Re: Village Board Review of ExteNet's Pending
Chapter 87 Permit Application, SEQRA and ROW Agreement

EXTENET RESPONSES TO VILLAGE BOARD QUESTIONS/COMMENTS
DATED NOVEMBER 10, 2014

**ANTENNA MOUNTED
 ON SECONDARY OR GUY
 DISTRIBUTION POLE**

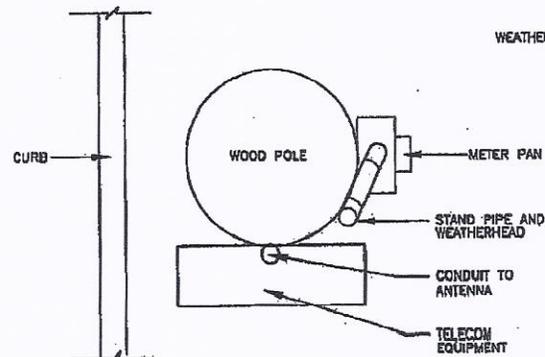
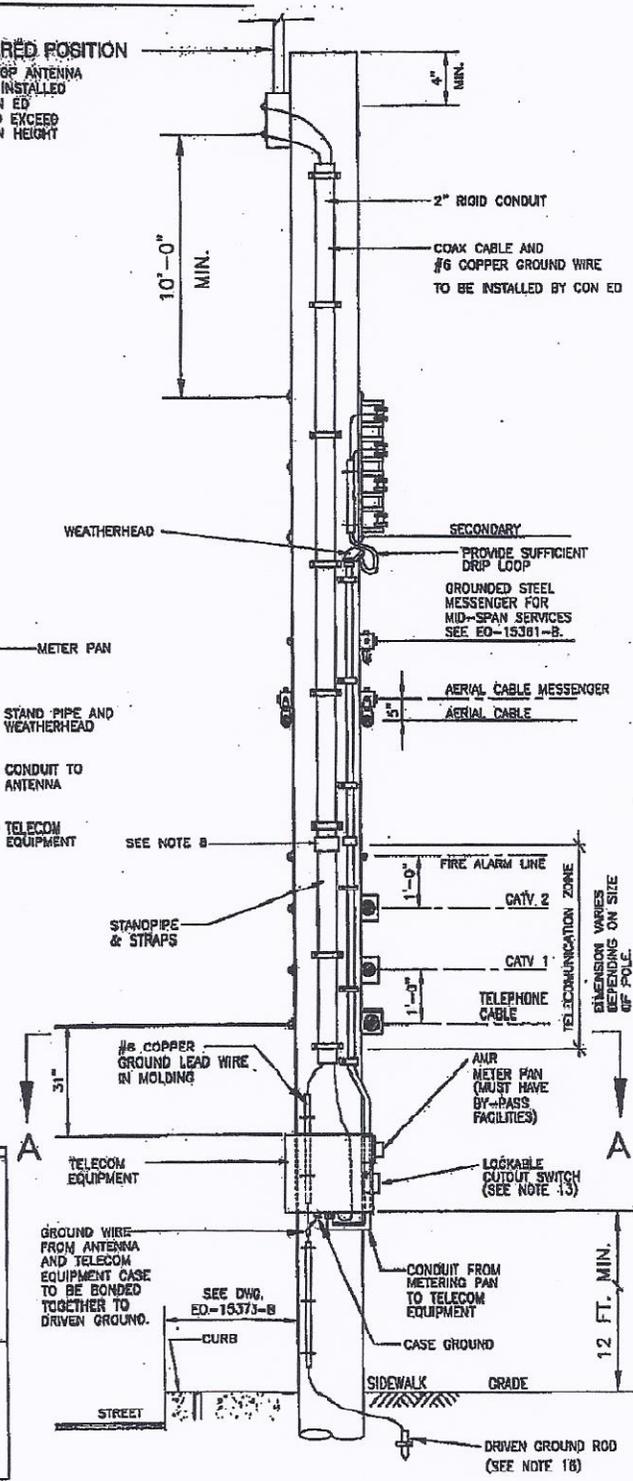
Please provide with respect to each pole that was discussed as being incapable of use for a DAS node, i.e., those in the vicinity of the Kaplan residence, as well as those heading north to the train station, either documentation from Con Edison that it will not allow the pole to be used or a detailed explanation that CTC can verify as to why the pole is unavailable for ExteNet's purposes.

Con Ed has numerous requirements that govern the terms and conditions of pole attachments by any other provider of telecommunications services (i.e. landline, cable, wireless) to ensure principally the ability to supply electric service and otherwise have attachments comply with the NESC and related codes. Con Edison and ExteNet are parties to a Wireless Services Agreement and Pole Attachment Agreements. As referenced in the agreements, all construction and/or pole attachments must be constructed in accordance with NYS PSC tariffs governing same and NESC code requirements. Attached are exhibits directly from ExteNet's agreements with Con Ed which identify and incorporate the limitations noted at the public hearing on November 6th on use of certain poles and wireless pole attachment design requirements.

Pelham Nodes
Prediction w/PLH003 Current
Ground Elevation = 105ft

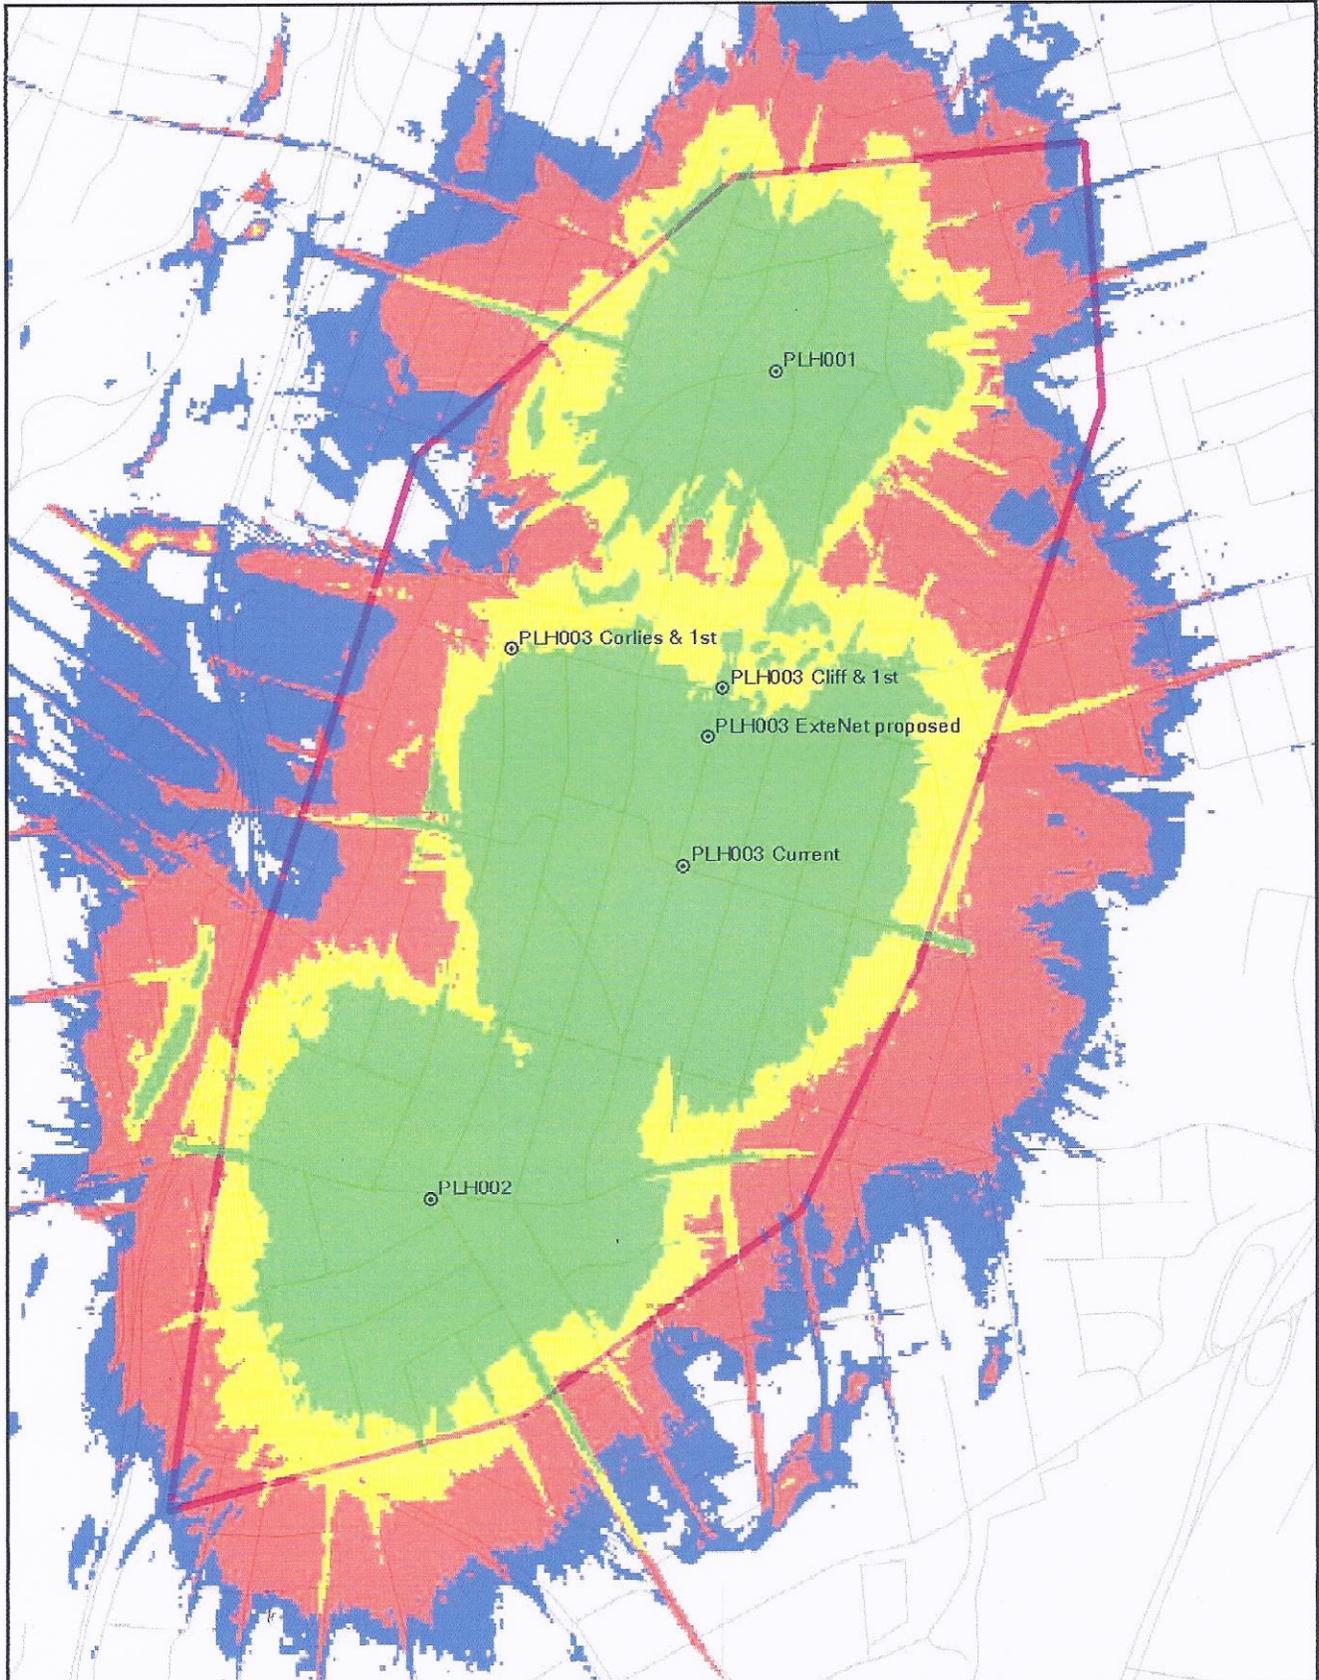
Chris Fridrich, ExteNet's Radio Frequency Engineer (as a supplement to his verbal testimony at the November 6th hearing) has prepared various propagation plots included in Attachment B in response to the Village's request for further information regarding alternatives. Please refer to Figure 1 in Attachment B for the current DAS network baseline coverage.

Please provide some documentation to support the statements made by ExteNet's representatives that a potential site in "the valley" will not substitute for a proposed site "on top of the hill."

Please refer to Figures 1, 2 and 3 in Attachment B for comparisons. Clearly, where the current PLH003 node is located is optimum for service; it is at a relative maximum ground elevation height in its vicinity (105ft) as well as virtually geometrically centered between nodes PLH001 and PLH002 equalizing the coverage between these nodes. Most importantly, it will provide the highest quality of service to more T-Mobile subscribers and other future users of ExteNet's DAS network than if the node were located elsewhere. Of note, not only is an 80ft wood pole in "the valley" by the railroad tracks not practical (or permissible by ConEd), but it causes other potential issues within the network related to interference as noted in Figures 4 and 5. Please also see the supplemental RF report prepared by T-mobile and Mr. Joseph Menio in Attachment C.

Please refer to Figure 1 in Attachment B; this plot was generated at 5m resolution. Green represents good in-building coverage. Yellow represents good in-car coverage. Blue represents good outdoor coverage. Red is the system threshold; users will be at the limit of being able to originate and maintain a call outdoors. Please also see the supplemental RF report prepared by T-mobile and Mr. Joseph Menio in Attachment C regarding its plots and resolution.

Pelham Nodes
Prediction w/PLH003 ExteNet Proposed
Ground Elevation = 82ft

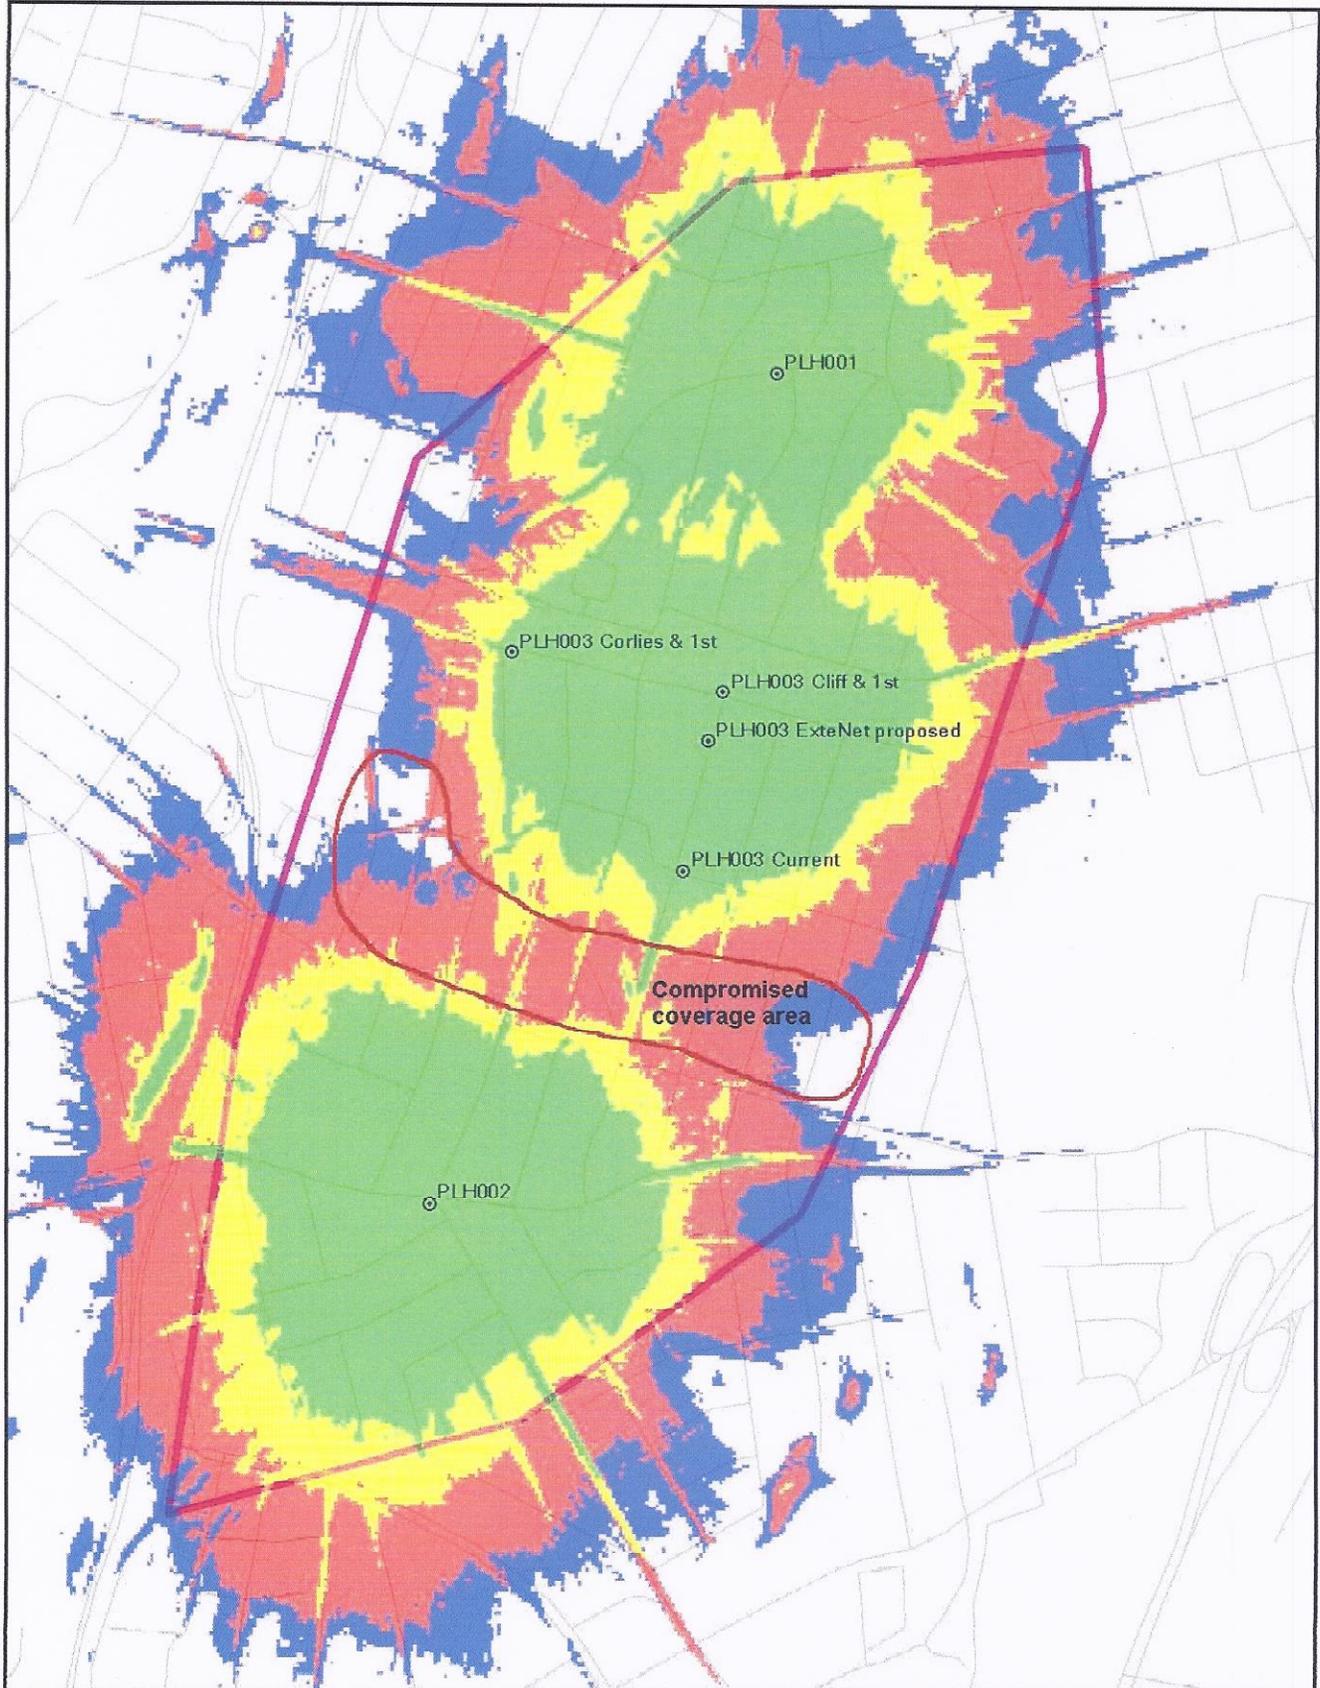
Please quantify, in a way CTC can verify, the diminution in service that would result from placing the node on the potential alternative site that you have identified as compared to the node proposed for the vicinity of the Kaplan residence. ExteNet has stated that the primary coverage extend out 1,000 to 1,200 feet. As was discussed at the hearing, moving the node 600 feet, or more, north will obviously compromise that coverage. Is that quantifiable?

If ExteNet shifted the node labeled PLH003 650' north along Cliff Ave (Figure 2) to the potential alternative site, there is compromised coverage overlap between node PLH002 to the south and this potential alternative location. With respect to other pole line locations in the vicinity of the train station or tracks, if ExteNet shifted the node to Cliff Ave & 1st which is at an even lower ground elevation (Figure 3), the same compromised area between nodes PLH002 and PLH003 becomes significantly larger and unacceptable for reliable service. If ExteNet were to shift the node to Corlies Ave and 1st (Figure 4), reliable coverage would be missing on the east side of the target area as well as the node would be propagating outside the target area and may cause interference issues with surrounding macro cell site service layers. If ExteNet were able to place an 80ft pole at Cliff Ave & 1st (Figure 5), comparable coverage could be matched to the baseline (Figure 1) between nodes PLH002 and PLH003, but that height would then significantly propagate outside the target area and have unacceptable overlap with service from node PLH001 to the north.

Yes. The reduction in coverage for existing node PLH003 in comparison with the potential alternative 650' north on Cliff Avenue is geographically identified on Figure 2 with the corresponding reduction in signal strength from -90 dBm to -98 dBm for a significant area in this part of the Village. T-Mobile subscribers (and likely those of future carriers that may use ExteNet's DAS system) that reside in the compromised area would have diminished or no reliable in-building service. This diminished coverage is qualitative and can be quantified by comparison to the aerial maps in Figure 1 to a significant number of homes south of 2nd street and north of 3rd street in a substantial area running east to west in Pelham. Please also see the supplemental RF report prepared by T-Mobile and Mr. Joseph Menio in Attachment C.
